Volume 3
Public Comments
and Responses

FINAL SUPPLEMENT ENVIRONMENTAL IMPACT STATEMENT

Waste Isolation Pilot Plant

DOE/EIS-0026-FS

FIGURE 1
TREATMENT OF COMMENTS

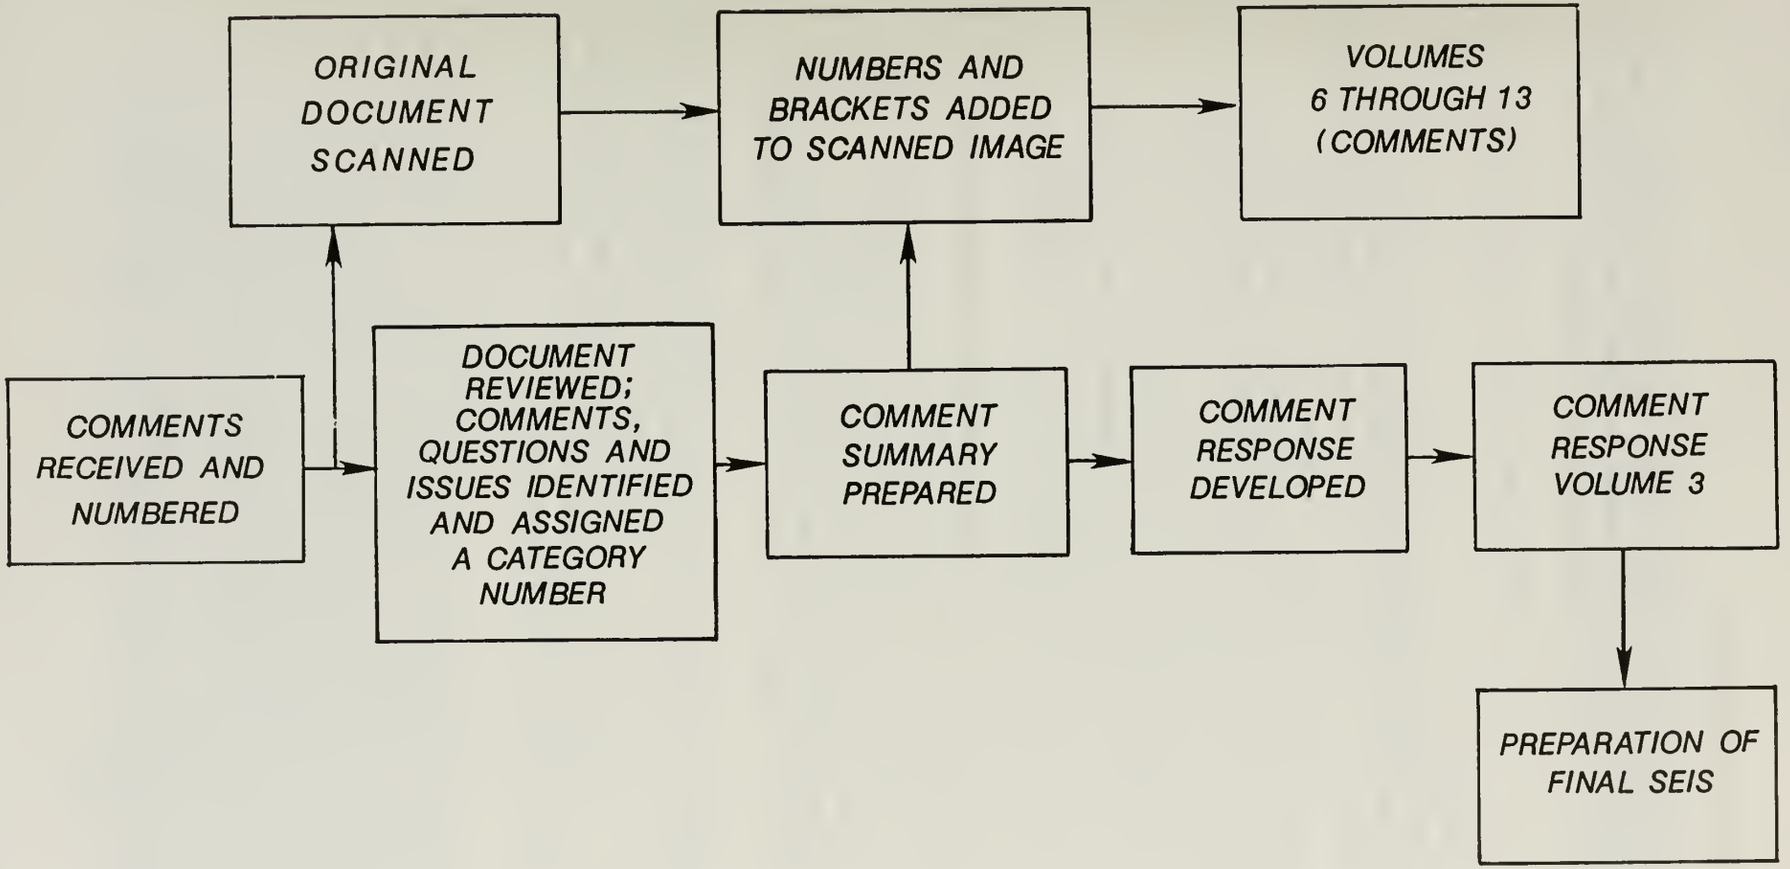
Figure 1 shows how the comments were handled from receipt to inclusion in the final SEIS.
